CONSTRUCTION PERMIT APPLICATION

Description of Work/Use: SIGN INSTALLATION REPLACE EIXSTING SIGNS ON LEFT & RIGHT FACADE W/ NON-ILLUMINATED CHANNEL LETTERS, SEE BLDG TECH FOR ADD'L INFO <COMMERCIAL>

DESCRIPTION OF WORK REPLACE EXISTING "FOOT LOCKER" SIGNS ON LEFT & RIGH FACADE WITH NON-ILLUMINATED CHANNEL LETTERS
REPLACE EXISTING "FOOTLOCKER" FRONT FACADE ILLUMINATED SIGNAGE WITH NEW UL APPROVED ILLUMINATED SIGNAGE.
REPLACE EXISTING "FOOTLOCKER" FACES ON PYLON WITH NEW 7-ELEVEN FACES

The following comments were made during the Plan Review process:

DF Directional

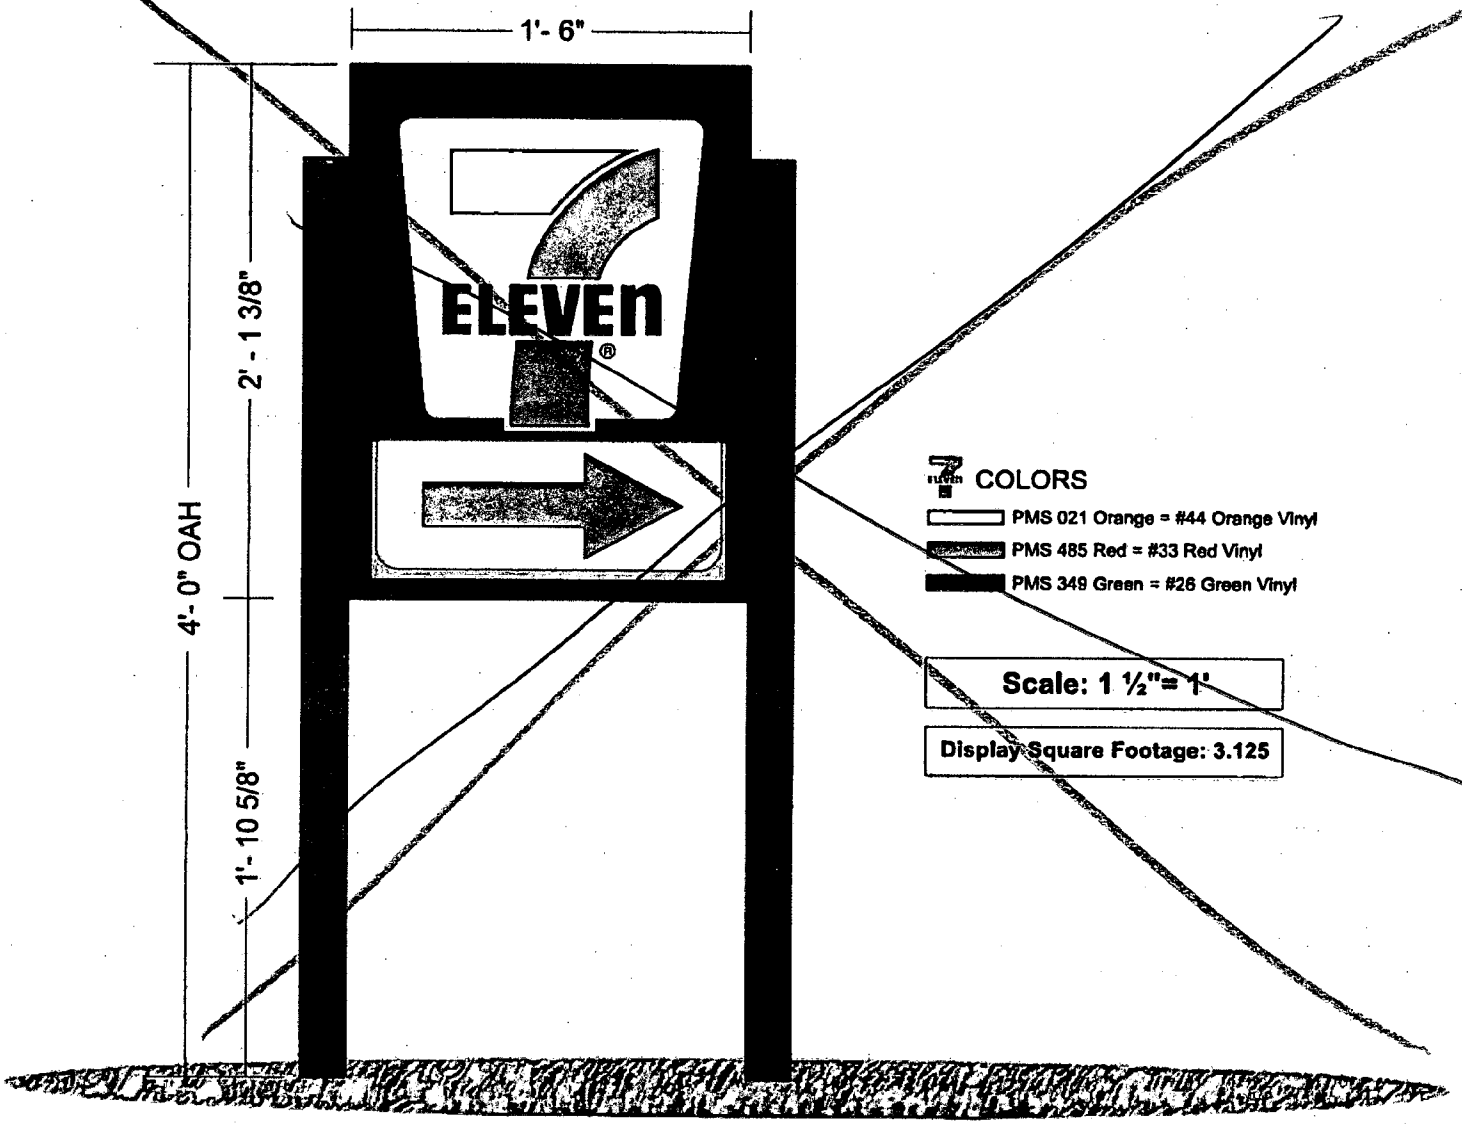
Your zoning permit application for the referenced property cannot be approved because the logo on the proposed directional sign cannot be larger than the direction word or symbol. Please meet with the Permit Clerk and submit a revised application.

12/1/09 - Resubmit SK

TITLE:
7 ELEVEN, SEI FASCIA ILLUMINATED CABINETS
PERMIT DRAWING

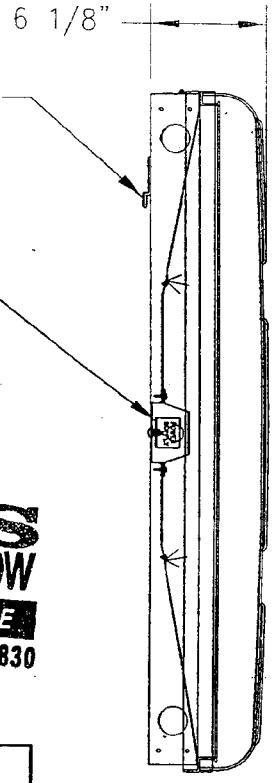
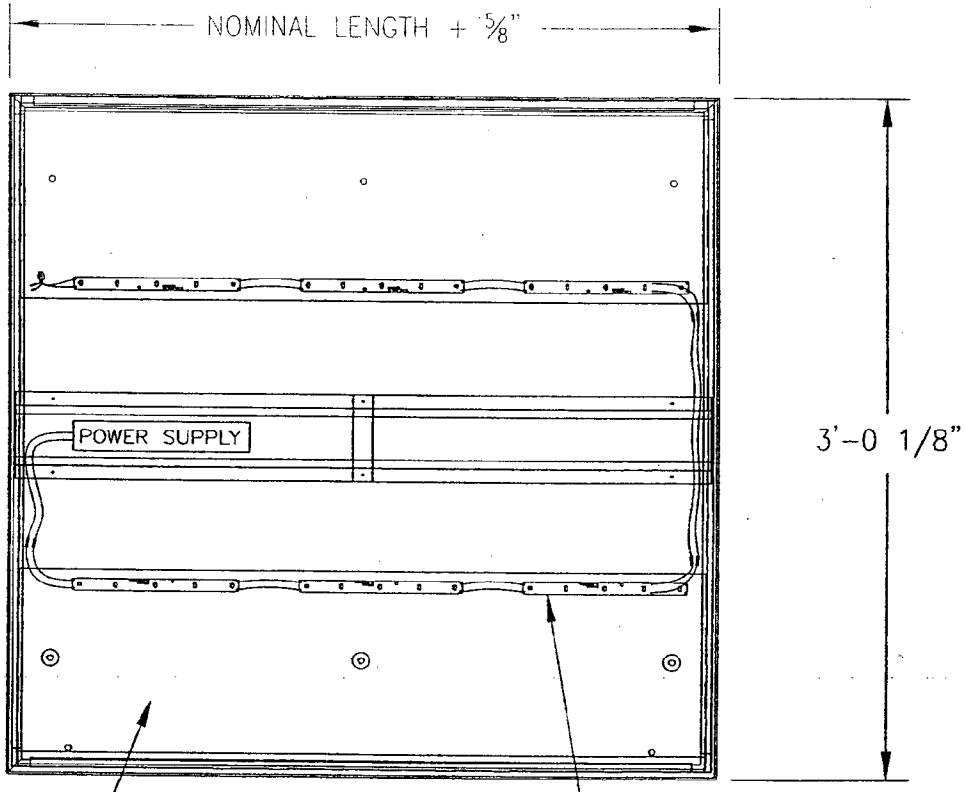
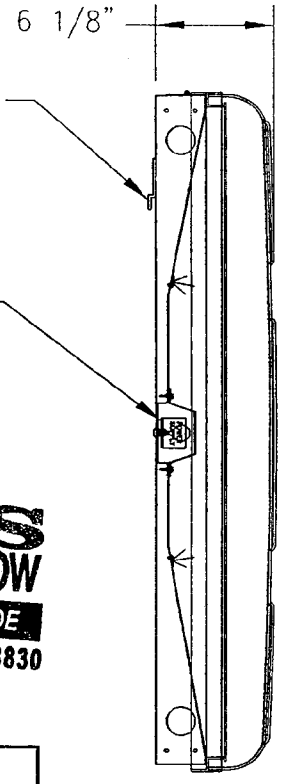
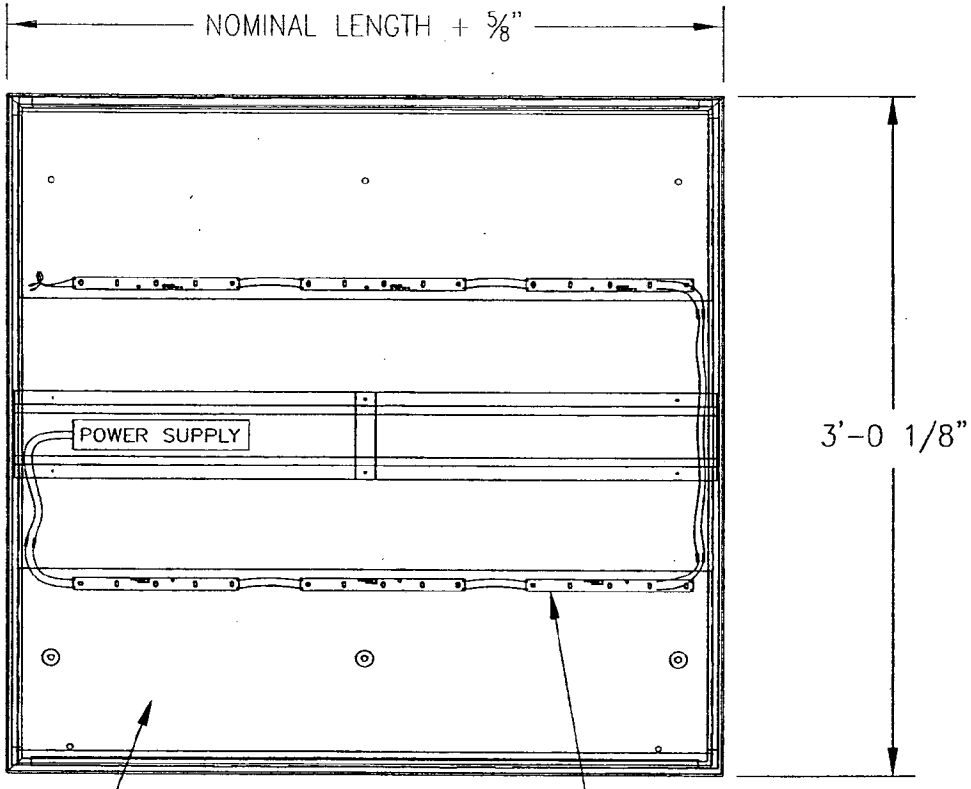
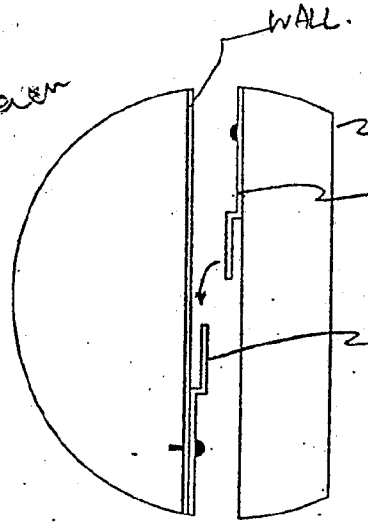
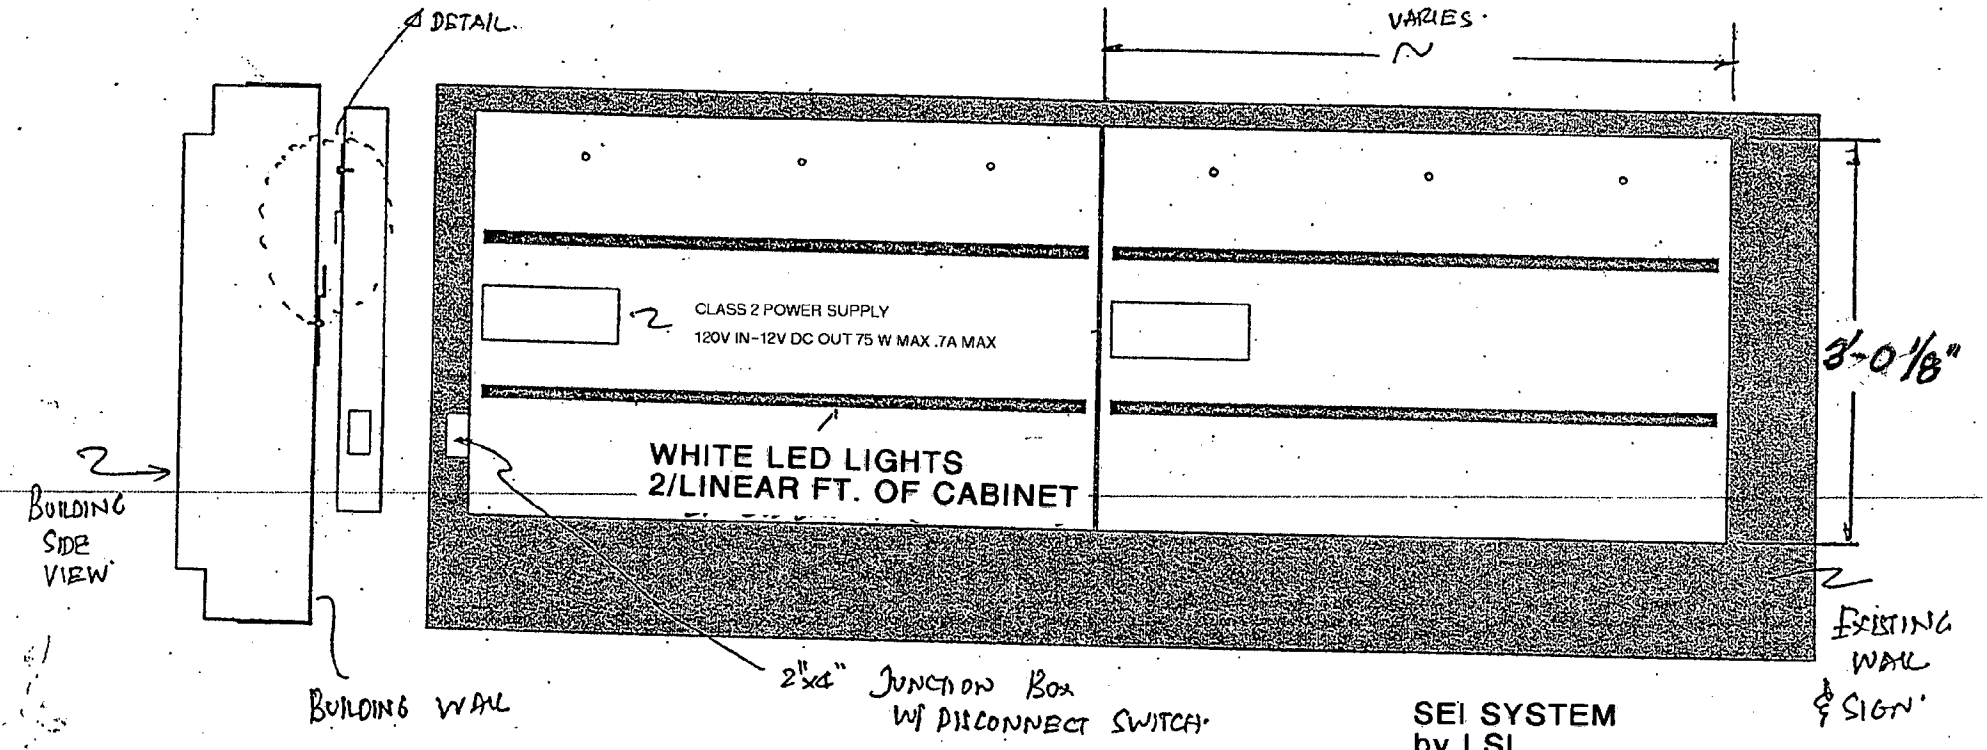
Sign mounting details/design must be by NJ professional engineer. Must use 115mph minimum wind speed design. Submit 2 sealed sets of plans.

As per your Subcode Review dated December 18, 2010.
I am enclosing the necessary signed and sealed sign mounting details/design.
I hope that this will suffice.
Earlier in the week I spoke with Jim in your office and we discussed what was needed. These drawings cover the illuminated sign on the front façade and the individual non-illuminated letters on both sides of the building. Jim advised me to let you know that the existing "Freestanding Sign" will have a face change only and that was approved by Zoning .
